Access Compliance Report

Public Rights-of-Way (Curb Ramps)

Intersection ID: 42580	Main Street: GERALDINE_POWE_DR	Cross Street: RISING_OAK_DR	Location: SE
ADA ID: E4E94F6B2B91	Ramp Type: Perp	Initial Pass/Fail: Pass	Overall Compliance: No
		Severity Score: 5

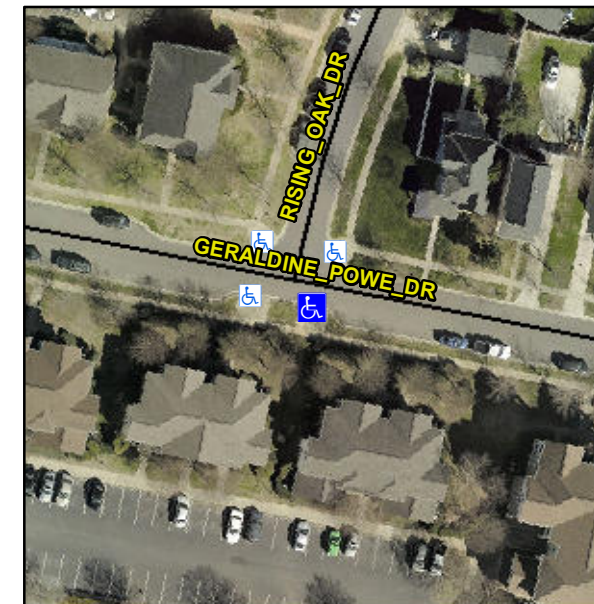
**Not Found, R304.2.1, R302.7,
R304.5.4**

**Remove & Replace Entire Ramp.
Remove & Replace Gutter.**
